Agenda Item Staff Report

Subject: **Metro Gold Line Foothill Extension Azusa to Montclair Project (Phase 2B)**

Bonita/Cataract Intersection Grade Crossing

GOLD LINE FOOTHILL EXTENSION
PRELIMINARY ENGINEERING
GRADE CROSSING AT
W. BONITA AVE. AND CATARACT AVE.
ALTERNATIVE NO. 3

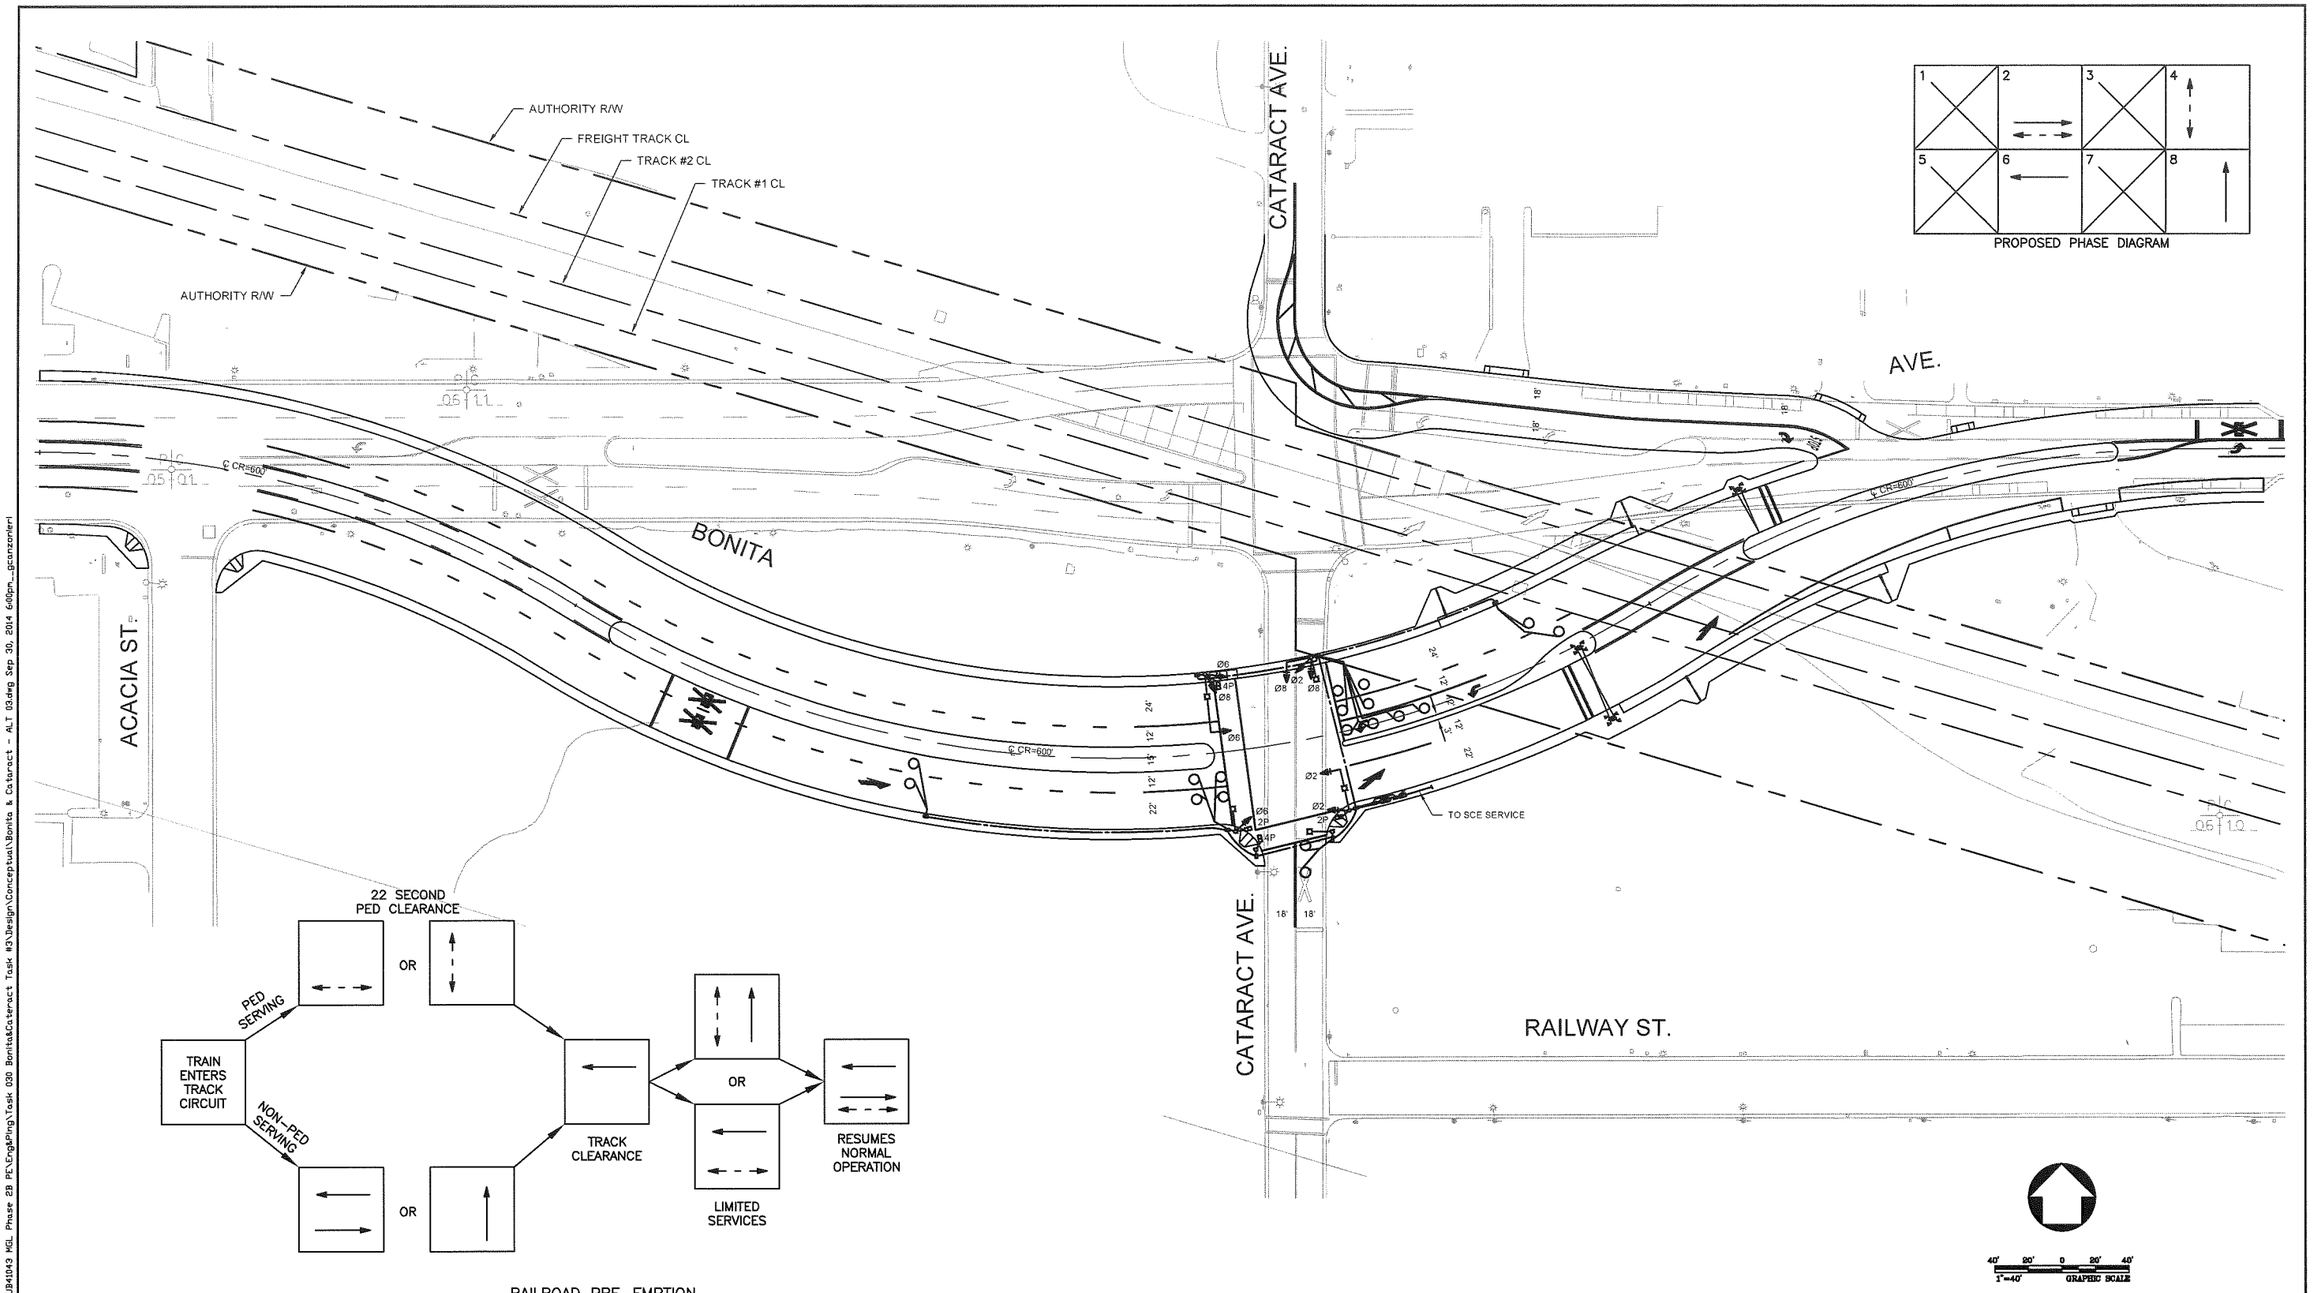
Alternative 3 would entail redesigning and realigning the entire intersection layout by shifting approximately 200 feet south of the existing Bonita/Cataract intersection. This would result in following pros and cons in terms of improvements.

Cons:

- Negative impact for neighborhoods and access to north Cataract Avenue
- Directs more traffic on Monte Vista north since no left turn movement on Bonita
- Restricts access to business on Bonita Ave
- Move crossing gates for pedestrians
- Expensive costs for R.O.W. construction
- Reduces the potential viability of development value of large city property
- Remnant property between north curb line and Authority ROW track undevelopable.

Pros:

- Plan developed for traffic on Bonita at expense of Cataract
- Lane drop over tracks

METRO GOLD LINE FOOTHILL EXTENSION CONSTRUCTION AUTHORITY
GOLD LINE FOOTHILL EXTENSION PHASE 2B
GLENDORA TO MONTCLAIR
BONITA / CATARACT GRADE SEPERATION

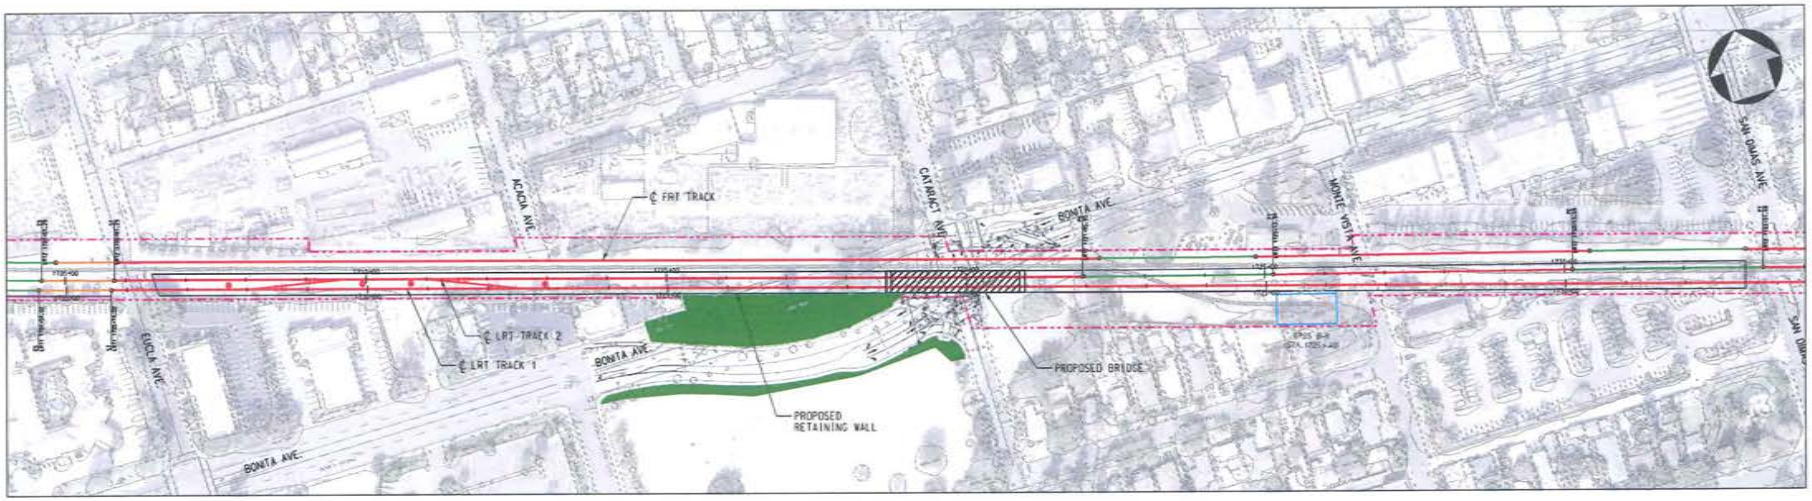
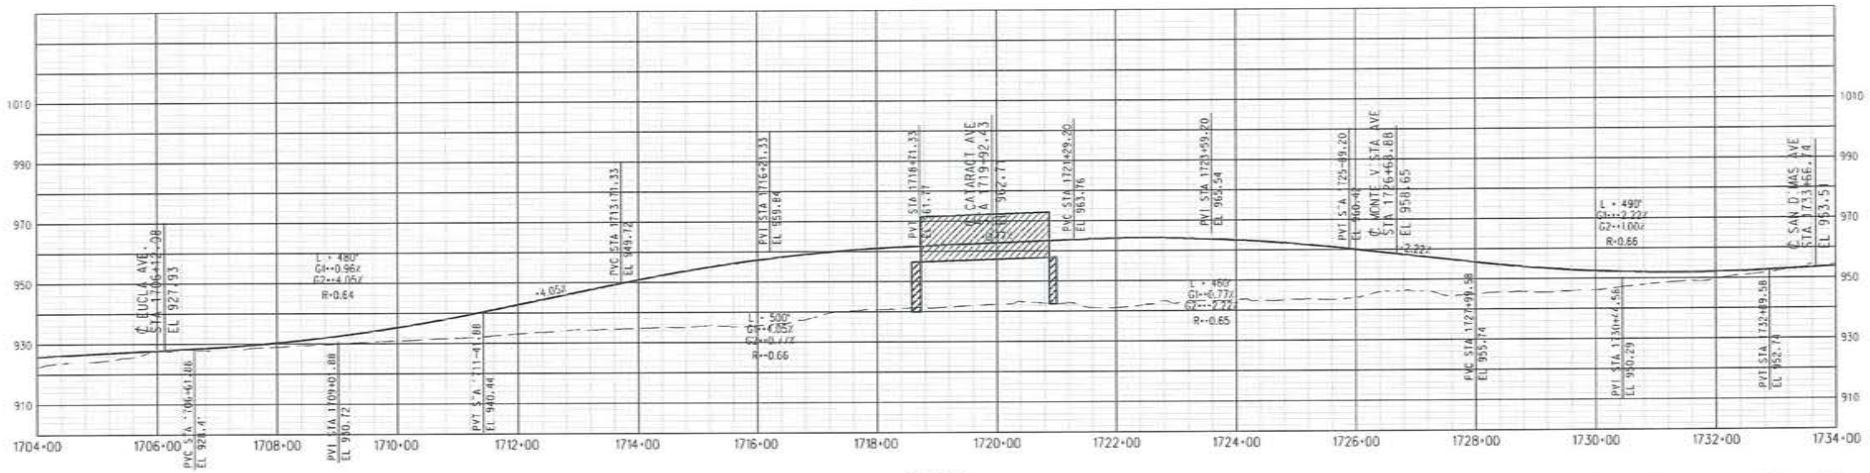
The Authority has primarily designed the alternatives with the train in mind, but not really assessing the impact this would have on the traffic flow in our downtown or its subsequent long term impact on businesses. While the Authority continues to state this intersection does not meet MTA grade crossing policy. Staff feels that Bonita/Cataract does merit a "unique" consideration for an above street grade separation that is above and beyond MTA's policy that is primarily based on high traffic volume that our intersection will never meet. For an above street grade separation for the light rail tracks will provide the following benefits:

- Minimize traffic impact and circulation to our downtown
- Enhance business traffic and pedestrian safety
- Bridge façade/ parapets and columns which can be designed with art features (or mosaics) which could visually amplify our downtown's entrance quite possibly with an exclamation point if aesthetically designed to show our City's character and ambience.

The negative of this grade separation is that the:

- Bridge structure is a large, visual and could be perceived by some as an intrusive barrier as an entrance to our downtown
- Freight track will still remain
- Four crossing gates will required

In considering Staff's on-going concern regarding the intersection, it appears Authority Staff may have come to the similar conclusion and therefore have provided a preliminary flyover bridge plan and subsequent realignment plan of Bonita Avenue (Attachment C). This plan opens a dialogue between the agencies where we could work towards a flyover bridge that can be designed and developed to be visually attractive bridge that adds character to our downtown. As an example attached for Council's information are photos of bridges (Attachment D, Arcadia; Attachment E, Rancho Cucamonga) of what could be done to make a structure more aesthetically pleasing and inviting as we move forward.

Despite the visual constraints mentioned on the above street grade, Staff feels that the City should pursue and direct the Authority to include a grade separation at Bonita/Cataract as part of their overall project.
